## **INFIRMARY FOUNDATION SPRING HILL** **SUBDIVISION**

APPLICATION NUMBER 5 DATE April 17, 2014

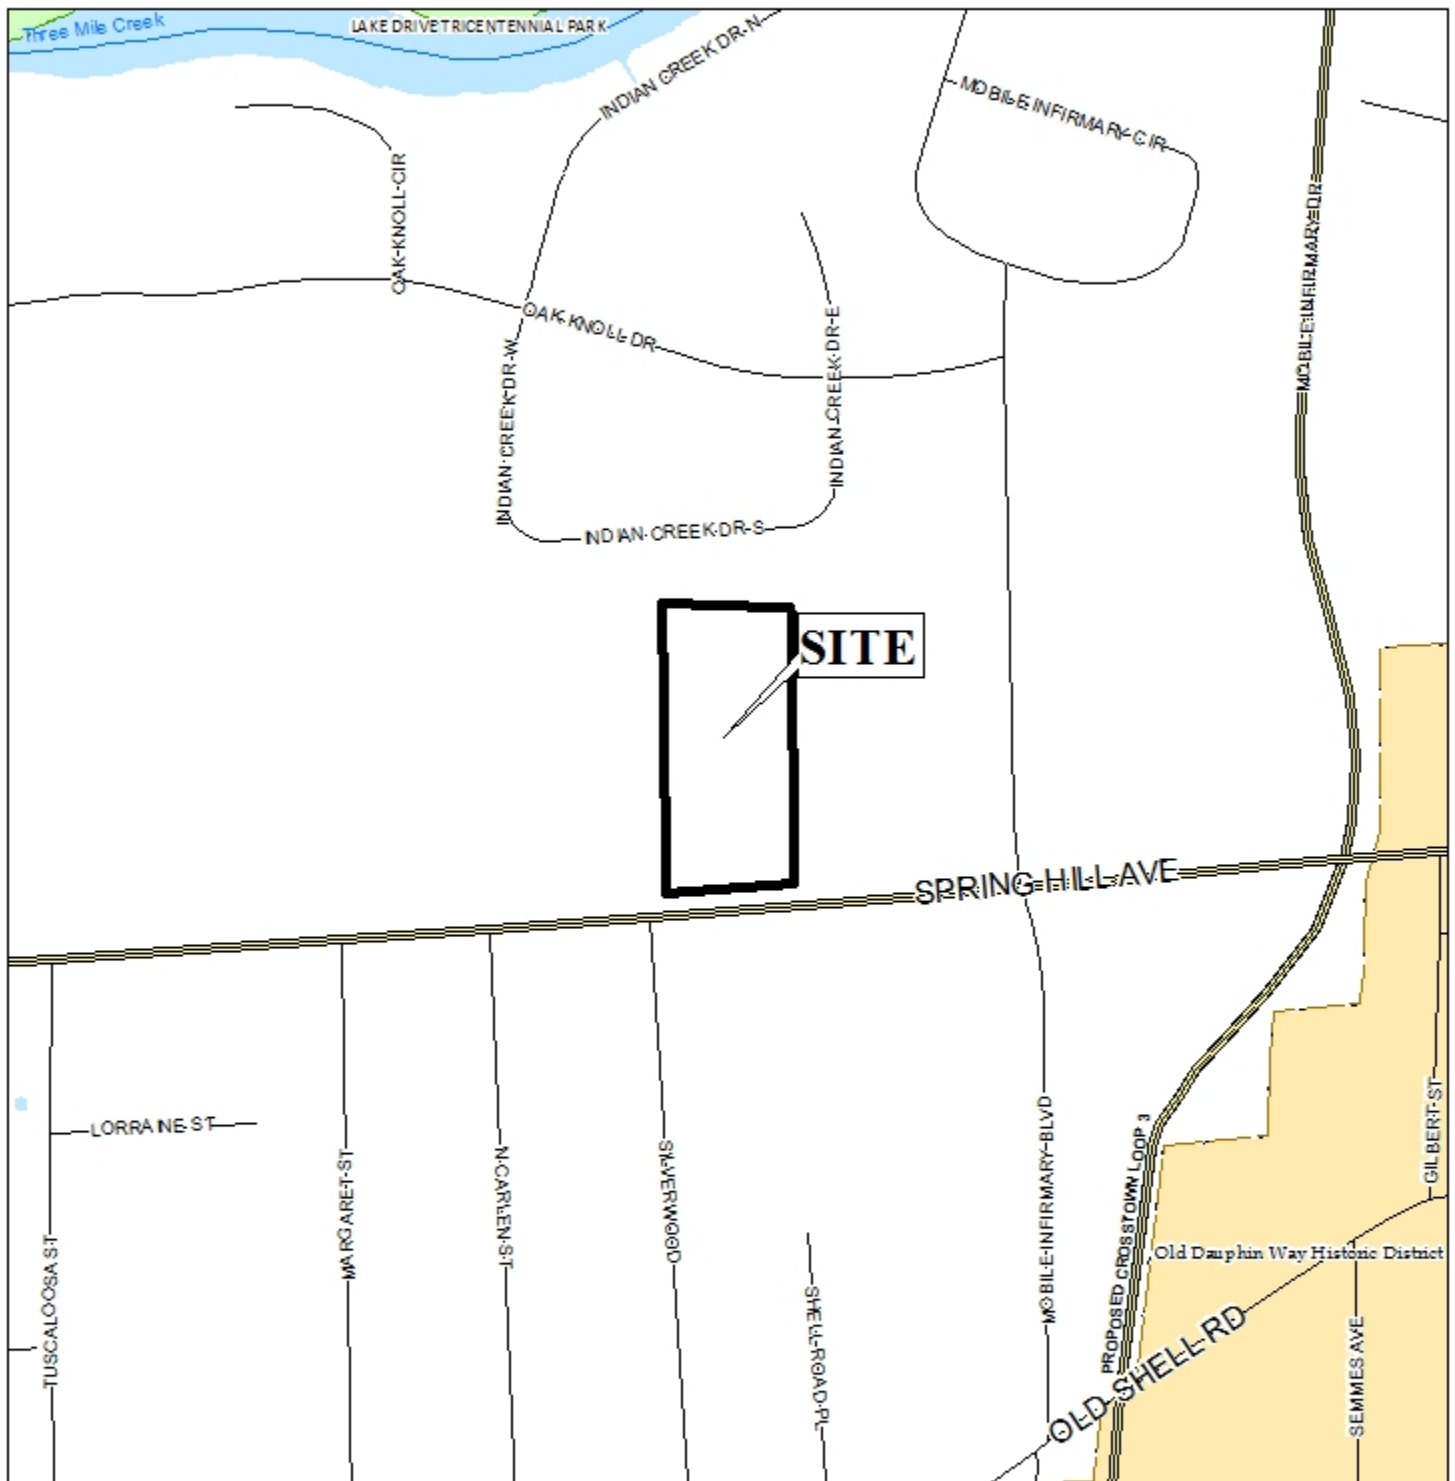
- A. Add a note to the SUBDIVISION PLAT stating that as shown on the 1984 aerial photo (FLIGHT 27 - #72) the Lot will receive historical credit of impervious area towards storm water detention requirement per the Storm Water Management and Flood Control Ordinance (Mobile City Code, Chapter 17, Ordinance #65-007 & #65-045), latest edition. Coordinate with City Engineering Department staff to establish the exact amount prior to the submittal of the Land Disturbance Permit application.

- B. Add a note to the Plat stating that the approval of all applicable federal, state, and local agencies (including all storm water runoff, wetland and floodplain requirements) will be required prior to the issuance of a Land Disturbance permit.

- C. Revision of the plat to label each lot with its size in acres and square feet, or the furnishing of a table on the Plat providing the same information;

- D. Provide the Owner's (notarized), Planning Commission, and Traffic Engineering signatures.
- E. Add a note that the easternmost driveway curb cut (vacant) shall be removed, the middle driveway curb cut (east side of circular drive) shall be replaced with a commercial curb cut, and any cracked or broken sidewalk panels will be required to be replaced at time of development.

- F. Remove the County Engineer's signature block from the Plat. The County Engineer no longer signs plats within the municipal limits of the City of Mobile.

The plat illustrates the proposed 1 lot, 3.7 ± acre subdivision which is located on the North side of Springhill Avenue, 450' ± West of Mobile Infirmary Boulevard, and is in Council District 1. The applicant states that the subdivision is served by public water and sanitary sewer.

The site has two existing curb-cuts. There is an existing circular driveway, which necessitates both curb-cuts. If approved, a note should be placed on the Final Plat stating that the lot is limited to two curb-cuts onto Spring Hill Avenue with size, design, and location to be approved by Traffic Engineering and ALDOT, and conform to AASHTO standards.

The 25-foot minimum building setback line is depicted on the preliminary plat and should be retained on the Final Plat, if approved.

The lot size is illustrated in square feet and acres on the preliminary plat and should be retained on the Final Plat, if approved.

It should be noted, due to the fact the site abuts residential property, a 6' high 10' wide vegetation buffer or 6' high wooden privacy fence will be required along the western and northern perimeter of the site.

Based on the preceding, the application is recommended for Tentative Approval, subject to the following conditions:

- 1) placement of a note on the final plat stating that a buffer in compliance with Section V.A.8. of the Subdivision Regulations will be required;
- 2) placement of a note on the Final Plat stating the lot is limited to two curb-cuts onto Spring Hill Avenue, with the size, design, and location to be approved by Traffic Engineering and ALDOT, and conform to AASHTO standards;
- 3) retention of the 25' minimum building setback line on the Final Plat;
- 4) retention of the lot size in square feet and acres, or the furnishing of a table on the Final Plat providing the same information;

- 5) placement of a note on the Final Plat stating that approval of all applicable Federal, state and local agencies is required for endangered, threatened or otherwise protected species.
